Access Compliance Report Public Rights-of-Way (Curb Ramps)

Intersection ID: 29384 Main Street: KIERNAN_DR Cross Street: PLEASANT_DALE_DR Location: SE

ADA ID: 83A9555034CF Ramp Type: PerpDiag Initial Pass/Fail: Fail Overall Compliance: No Severity Score: 13.75

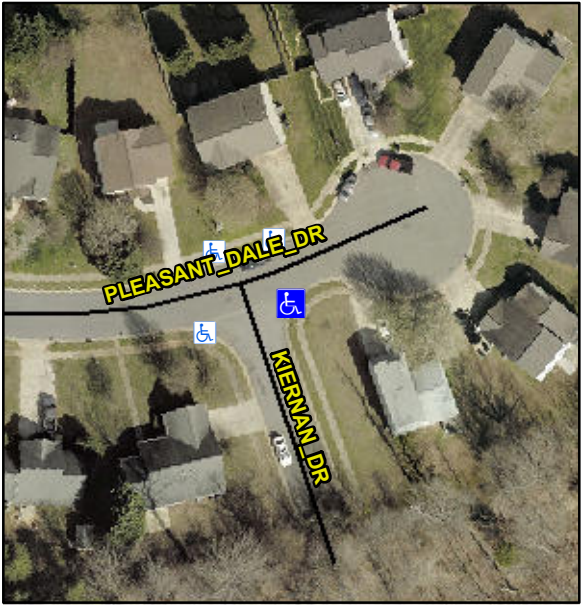
PROW/ADA:
Not Found, R304.2.2, R304.5.3

Compliance	Description	Data	Compliance	Description	Data
N/A	Ramp Length (in)	48.0	No	Ramp Slope (%)	8.9
Yes	Ramp Width (in)	48.0	No	Ramp XSlope (%)	3.8
N/A	Flare Type LT	N/A	N/A	Flare Type RT	N/A
N/A	Flare Slope LT (%)	N/A	N/A	Flare Slope RT (%)	N/A
N/A	Flare Traversable LT?	N/A	N/A	Flare Traversable RT?	N/A
N/A	Landing Length (in)	N/A	N/A	DWS Provided?	N/A
N/A	Landing Width (in)	N/A	N/A	DWS Contrast?	N/A
N/A	Landing Slope (%)	N/A	N/A	DWS Length (in)	N/A
N/A	Landing X Slope (%)	N/A	N/A	DWS Full Width?	N/A
N/A	Landing Curb? (Y/N)	N/A	N/A	DWS Offset (in)	N/A
N/A	Shared Landing?	N/A			
N/A	Gutter Ponding?	N/A	N/A	Gutter Slope (%)	N/A
N/A	Gutter Lip Ht (in)	N/A	N/A	Gutter X Slope (%)	N/A
N/A	Painted X Walk1?	No	N/A	Painted X Walk2?	No
	X Walk 1 Direction	To N		X Walk 2 Direction	To W
N/A	X Walk 1 Width (in)	N/A	N/A	X Walk 2 Width (in)	N/A
	X Walk 1 Slope (%)	1.5		X Walk 2 Slope (%)	1.8
	X Walk 1 X Slope (%)	1.8		X Walk 2 X Slope (%)	3.8

Possible Solutions:
Remove & Replace Curb Ramp With Two New Directional Ramps or Equivalent.
